# Grants Reclamation Project

ACL Application Public Meeting | September 9, 2026

# ACL Application Revision 1

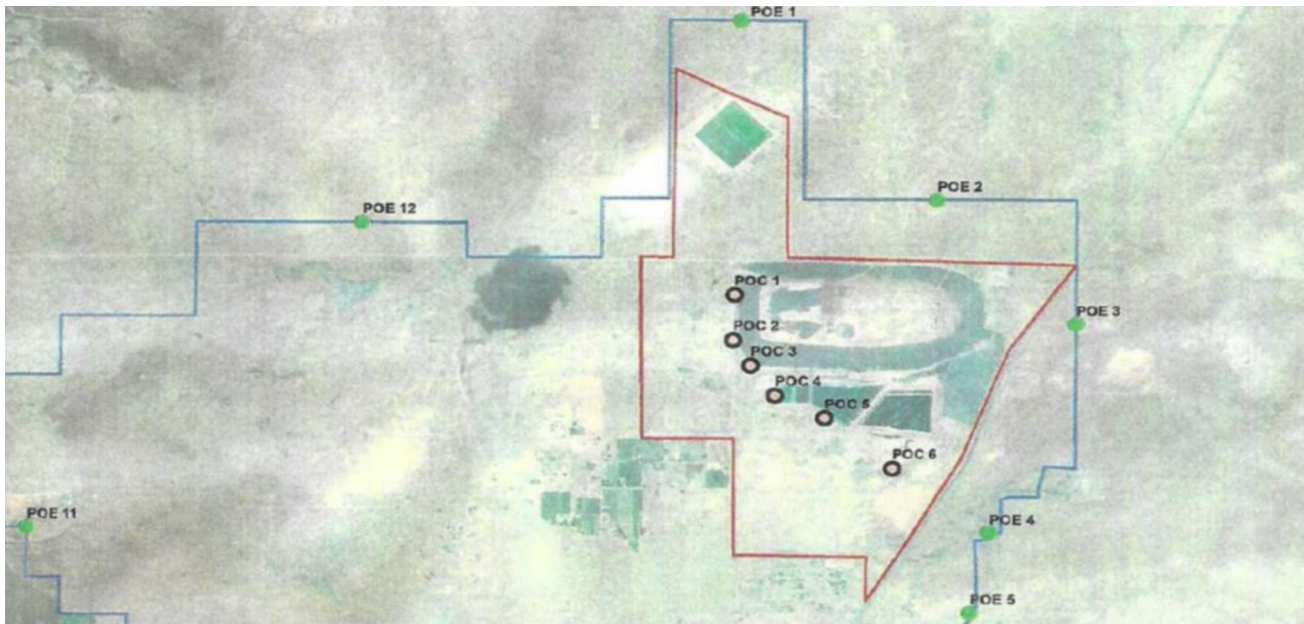
- What is the dark colored area to the west of the LTP in HBG's Enlarged Control Boundary shown on the map below?

- ❖ It is the shadow of a cloud.
